NUMBER: 07-001-22 REV. B

Water Pump Inlet Tube Fastener Torque

2018 - **2022** (JL)

Jeep Wrangler

Fig. 1
Water Pump Inlet Tube Fasteners

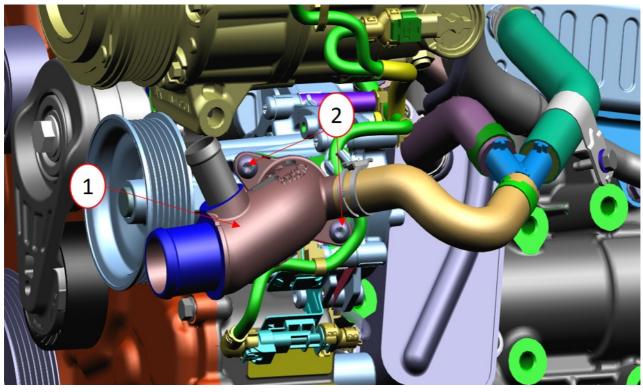
- 3. Was coolant found to be leaking from the water pump inlet tube at the engine (Fig. 1)?
 - YES>>> Proceed to Step 1 of the Repair Procedure.
 - NO>>> Coolant was not leaking from this area. This bulletin does not apply. Normal diagnosis should be performed.

1. Remove one inlet tube fastener (Fig. 1).

- 1 Water Pump Inlet Tube
- 2 Fasteners
- 2. Apply Mopar 04318031AC (or equivalent) to fastener thread.
- 3. Install the water pump inlet tube fastener and tighten to 11 N·m (97 in. lbs).
- 4. Remove the other water pump inlet tube fastener.
- 5. Apply Mopar 04318031AC (or equivalent) to fastener thread.
- 6. Install the water pump inlet tube fastener and tighten to 11 N·m (97 in. lbs).
- 7. Wait 10 minutes after last fastener is installed prior to pressure testing the coolant system or running the engine to allow for prescribed blue thread locking adhesive cure time.
